SUBJECT: Safety Recall 16S35

Certain 2014 Model Year Transit Connect Vehicles Equipped With Panoramic Roof
Panoramic Roof Panel Repair

CERTAIN 2014 MODEL YEAR TRANSIT CONNECT VEHICLES EQUIPPED WITH PANORAMIC ROOF — PANORAMIC ROOF PANEL REPAIR

FIGURE 3

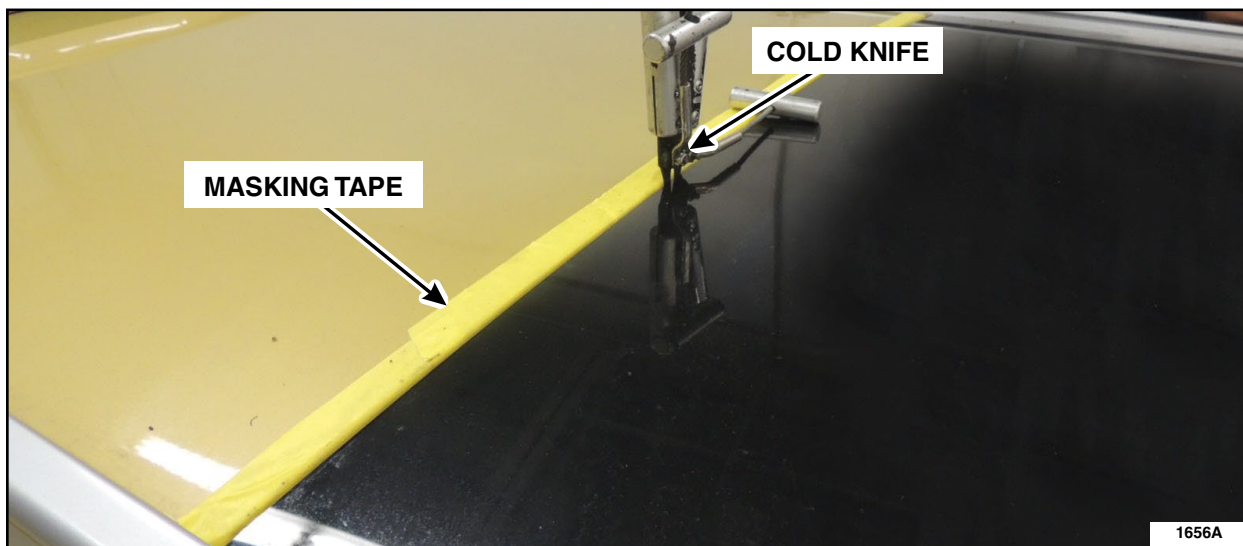
4. Using a cold knife, cut the urethane bead between the panoramic roof panel and body. See Figure 3.

IMPORTANT: ATTEMPTING TO CUT THE URETHANE BEAD IN LOW CLEARANCE AREAS CAN LEAD TO GLASS BREAKAGE.

- If the clearance between the panoramic roof panel and body becomes too tight and the cold knife begins to bind, discontinue cutting in that area and resume cutting the remainder of the urethane bead. Lift and reposition the panoramic roof panel slightly to allow the urethane bead in the low clearance area to be cut.

FIGURE 6

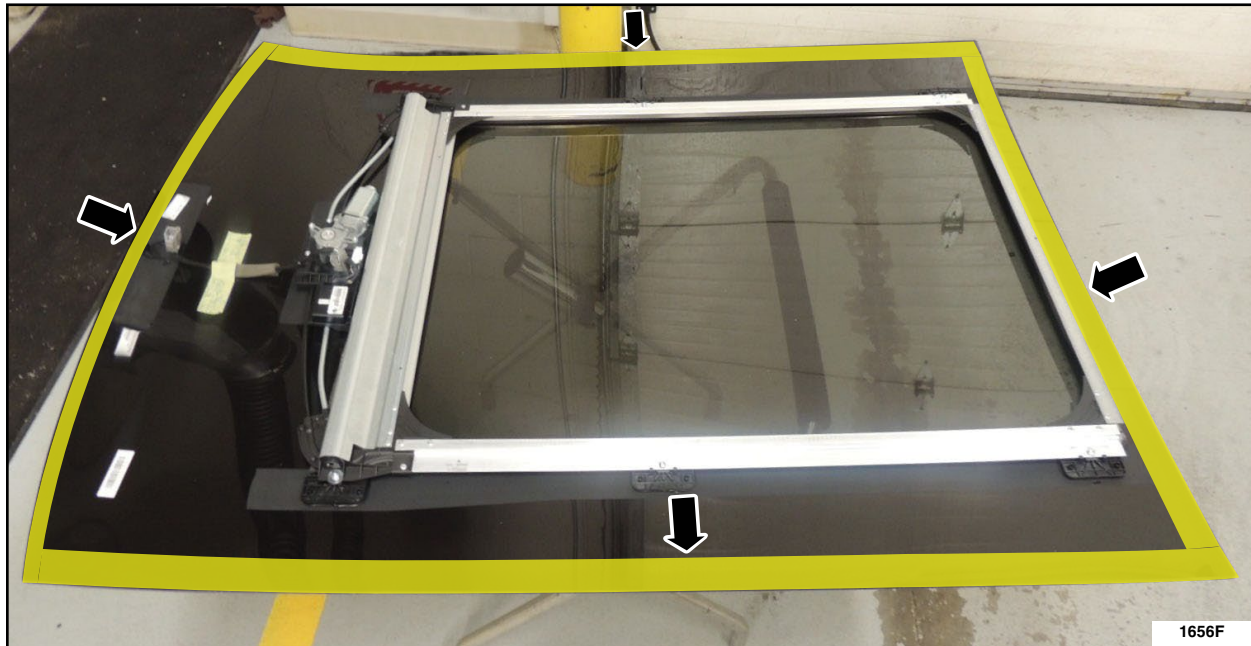
9. Prepare the panoramic roof panel for installation. See Figure 6.
- Clean the bonding surface using a *new* lint-free wiping tissue moistened with **acetone** for each edge of the panoramic roof panel. Wipe in a single direction using constant pressure to remove any contaminants. Repeat this step two additional times.
 - Clean the bonding surface using a *new* lint-free wiping tissue moistened with **isopropyl alcohol** for each edge of the panoramic roof panel. Wipe in a single direction using constant pressure to remove any contaminants. Repeat this step two additional times.

13. Apply primer to glass surface. See Figure 6.

- If using Dow® brand products, apply Dow® Betaprime™ 5504G primer.
- If using Sika® brand products, apply Sika® Aktivator Pro primer.

FIGURE 7

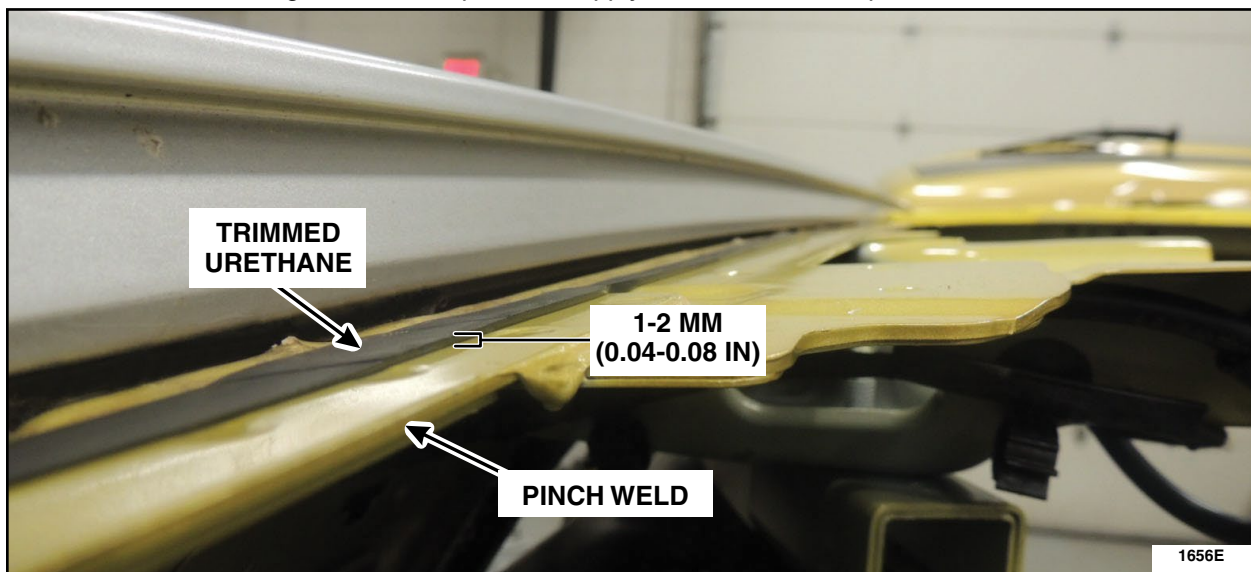
10. Prepare the vehicle pinch weld. See Figure 7.

- a. Trim the original urethane adhesive using a utility knife, leaving a 1 mm to 2 mm (0.04 in to 0.08 in) base on the pinch weld.
- b. Remove any foreign material or dirt from the pinch weld using a soft brush or vacuum.
- c. If any of the pinch weld metal was exposed during panoramic roof panel removal or urethane bead trimming, apply primer to the exposed metal.
 - If using Dow® brand products, apply Dow® Betaprime™ 5504G primer.
 - If using Sika® brand products, apply Sika® Primer-207 primer.
